Client: Rebecca Nichols
Drawing Number: P404_111
Drawing Title: Proposed Elevations
Date: 24/04/2025
Scale: 1:100 @ A4

P404_ 128 Old Lansdowne Road

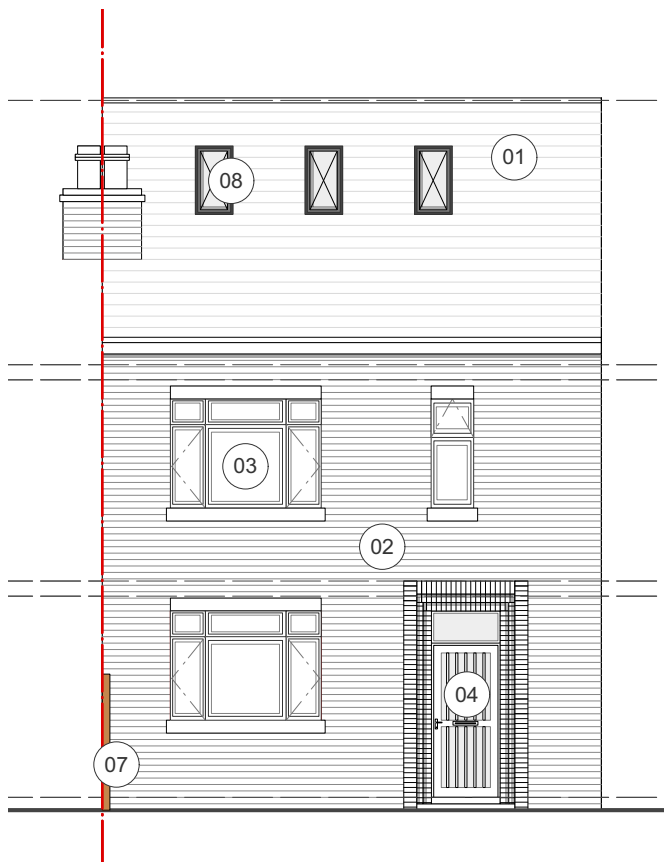
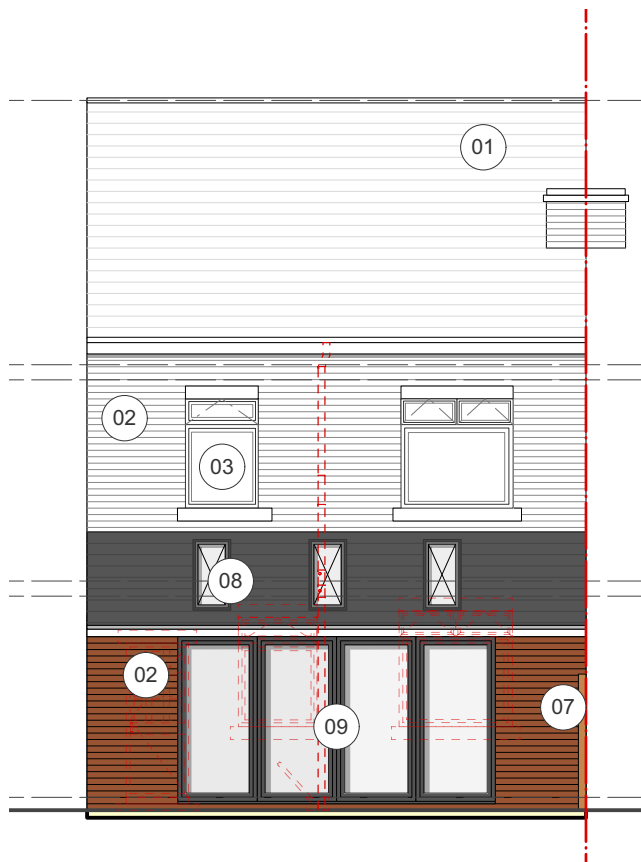
A 05/09/2025 Drawing status updated to Planning. Extension depth reduced to 4m in response to planner's comments dated 02.09.2025.
